*2<sup>nd</sup> Preliminary Consultation*  
**MONTGOMERY COUNTY HISTORIC PRESERVATION COMMISSION**  
**STAFF REPORT**

<b>Address:</b> 5415 Mohican Road, Bethesda	<b>Meeting Date:</b> 10/12/11
<b>Applicant:</b> Ross McNair and Alison Taylor	<b>Report Date:</b> 10/5/11
<b>Resource:</b> <i>Master Plan</i> Site #35/29, Baltzley Castle	<b>Public Notice:</b> 9/28/11
<b>Review:</b> 2 <sup>nd</sup> Preliminary Consultation	<b>Tax Credit:</b> Partial
<b>Case Number:</b> N/A	<b>Staff:</b> Josh Silver

**PROPOSAL:** Construction of addition and garage and other alterations

**REVISED PLAN**

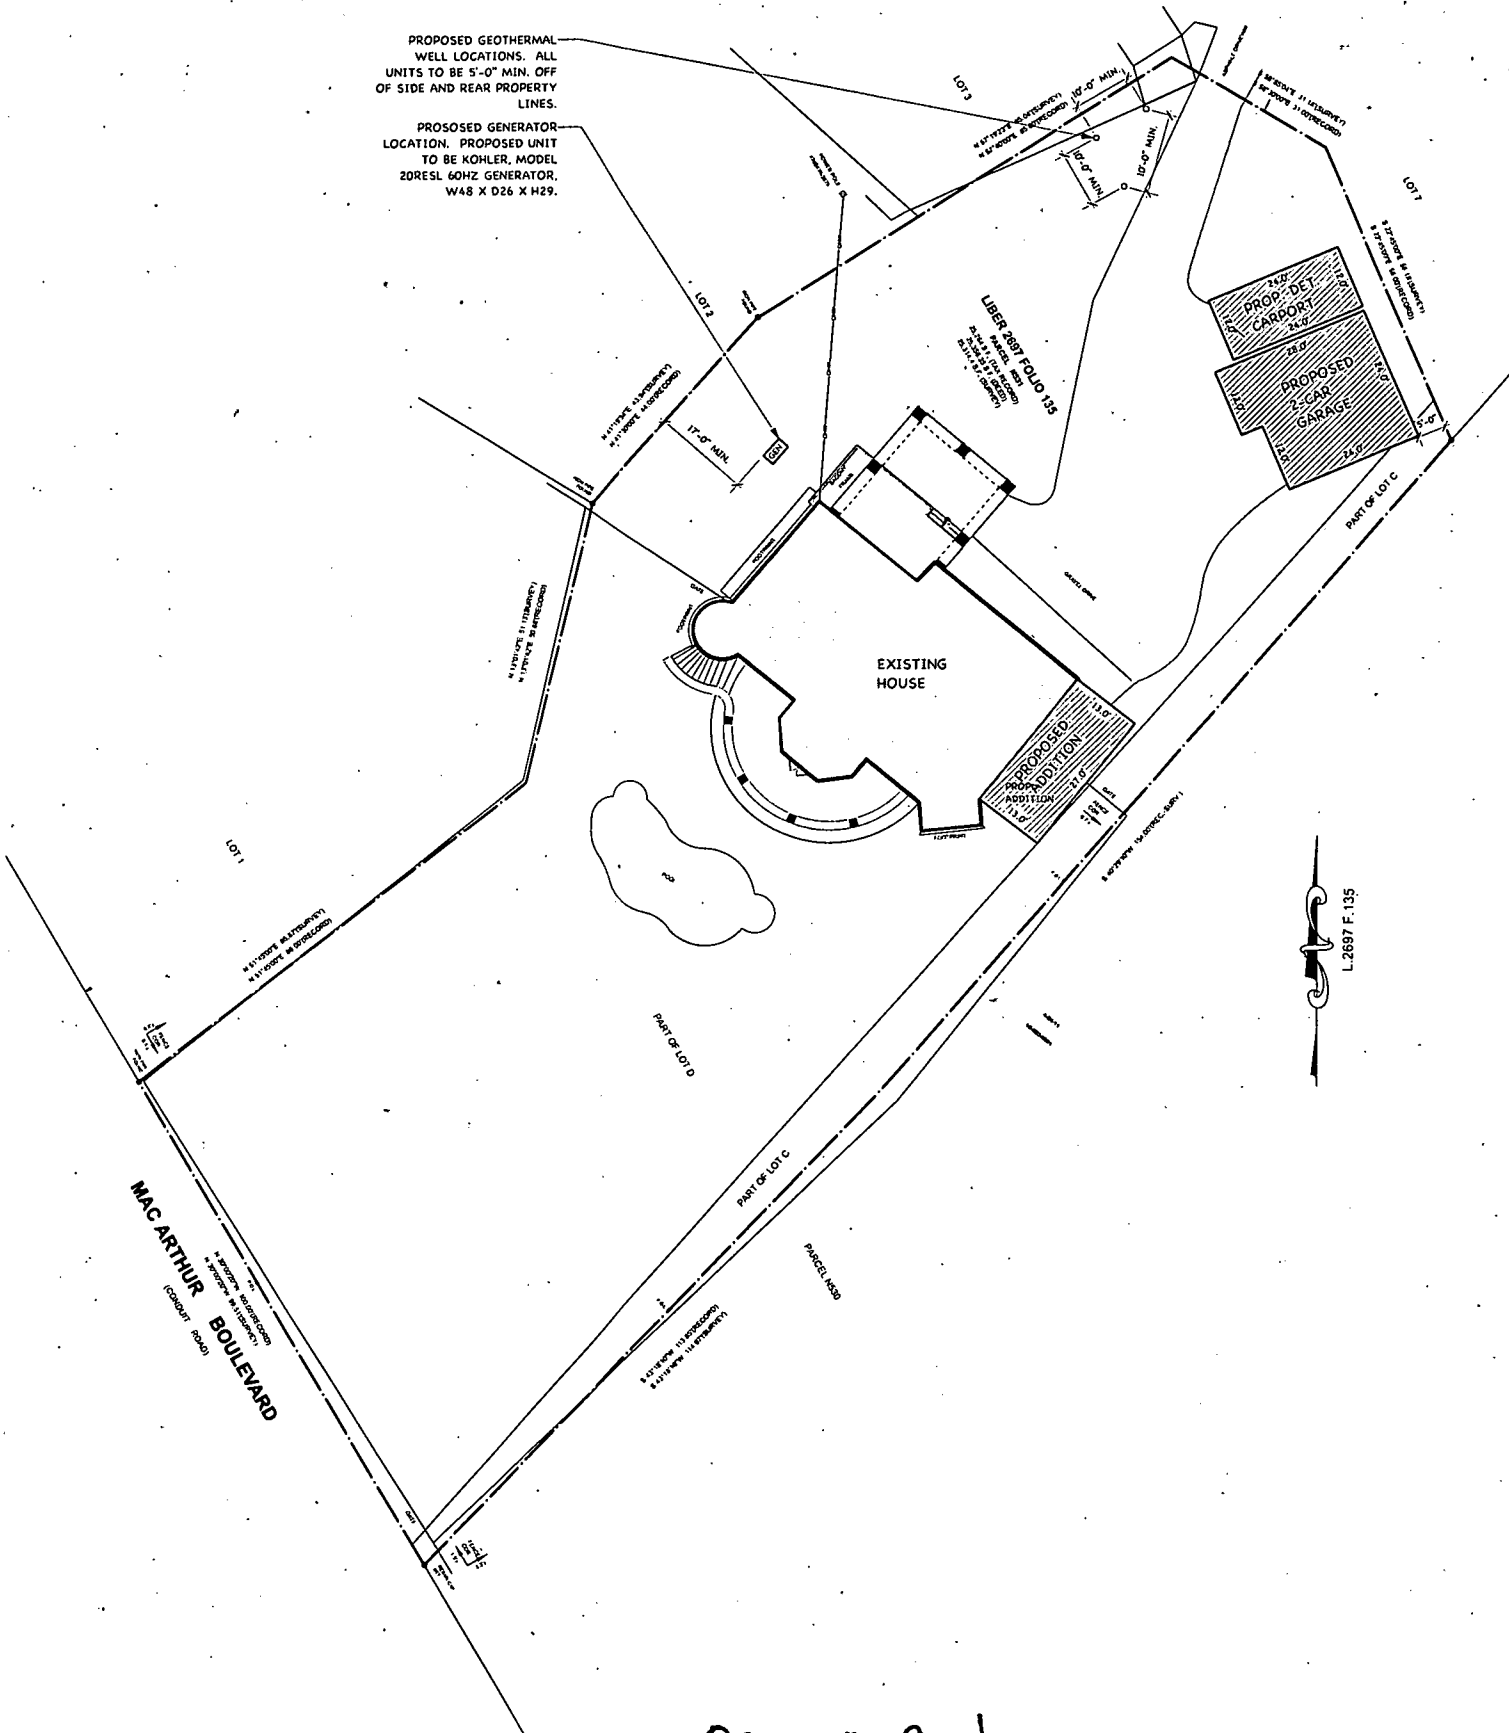
Staff supports the proposed construction of a two car garage with a single detached car port. The redesign responds to the HPC's feedback and is now compatible with the proposed two story addition and uses a flat roof form. The mass of the garage is broken up by the addition of a detached one car carport which helps mitigate its size. Furthermore, the proposed garage location, set within the existing ground slope coupled with the flat roof design should help mitigate some of the size and height concerns on the adjacent property. The applicants have confirmed the redesign complies with the properties established setbacks.

Staff supports the proposed installation of geo thermal wells and one generator at the property. The proposed installations will have negligible impact on the environmental setting.

1 FIRST FLOOR PLAN  
 SCALE: 1/8" = 1'-0"

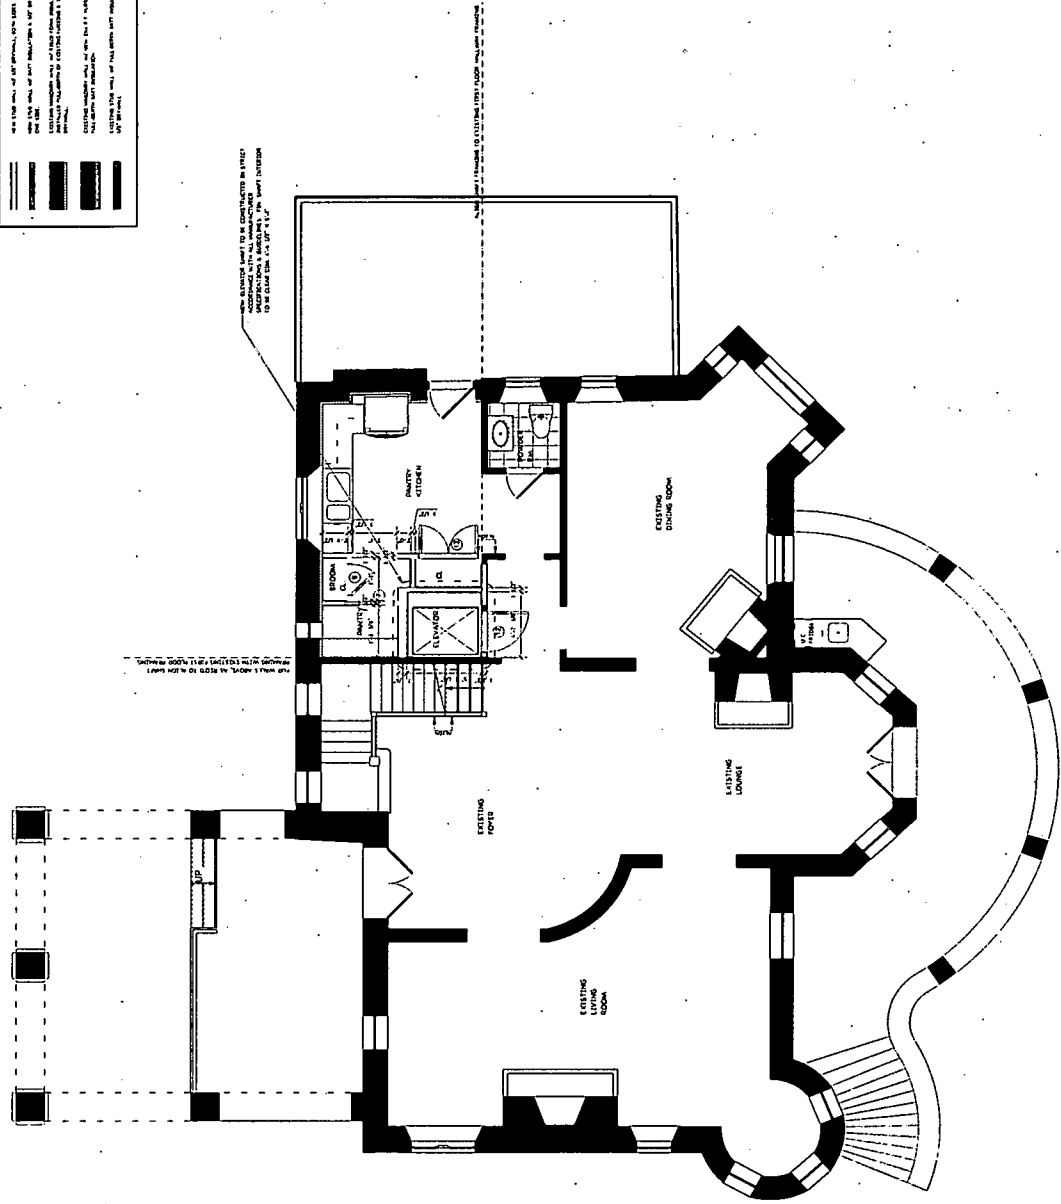
The proposed addition redesign responds directly to the HPC's feedback provided at the 1<sup>st</sup> Preliminary Consultation. The addition is placed behind and completely independent from the front tower and the issue of scale and expression has been addressed by using a more vertical window order and contemporary building design. The roof system was flattened to avoid competing with the 2<sup>nd</sup> floor and tower windows and a basic floor plan is provided to assist the HPC in their review of the revised plans.

24 FRONT PORCH DETAIL - PART SIDE ELEVATION

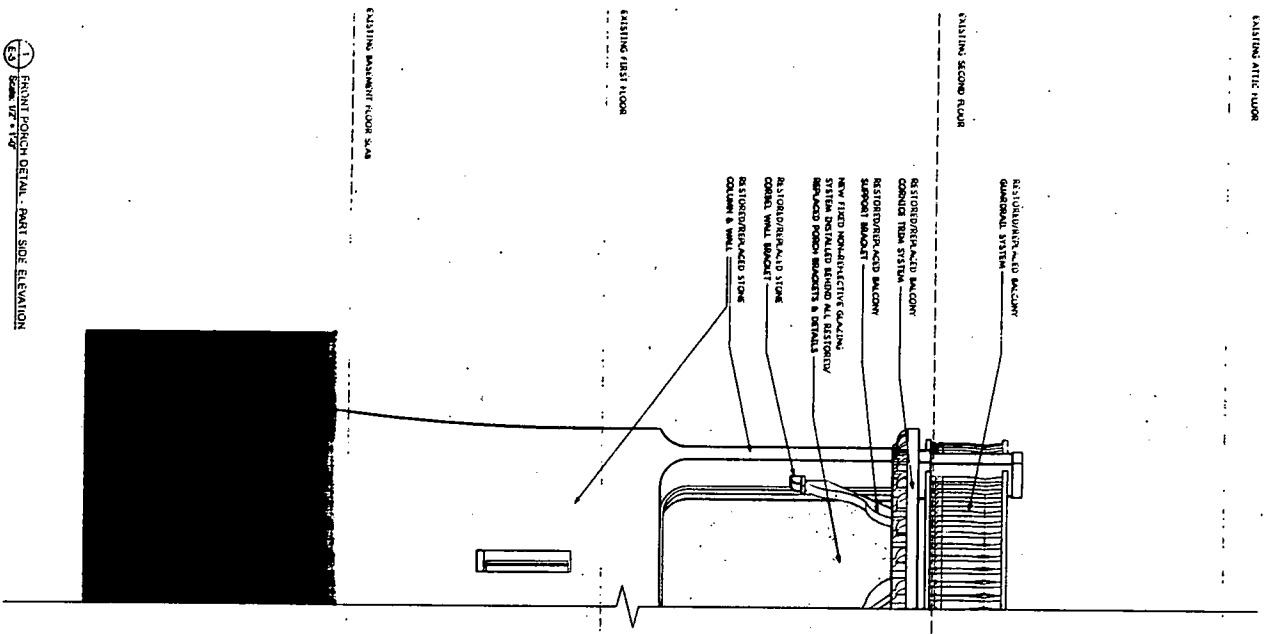
Staff supports the proposed installation of non-reflective glass in the openings of the front porch. The proposed installation of full view, fixed, non-operable glass sections behind the decorative wood brackets will have negligible impact on the structure and is consistent with Secretary of the Interior Standard's for Rehabilitation #1, 9 & 10. The applicant has provided additional details about the installation method of the glass and door to assist the HPC with their review of the proposal.

The proposed installation of non-reflective glass still allows the front porch to be used as a functional living space. The proposed installation method of the glass behind the decorative brackets does not destroy historic materials, features and or spatial relationships that characterize the property. The
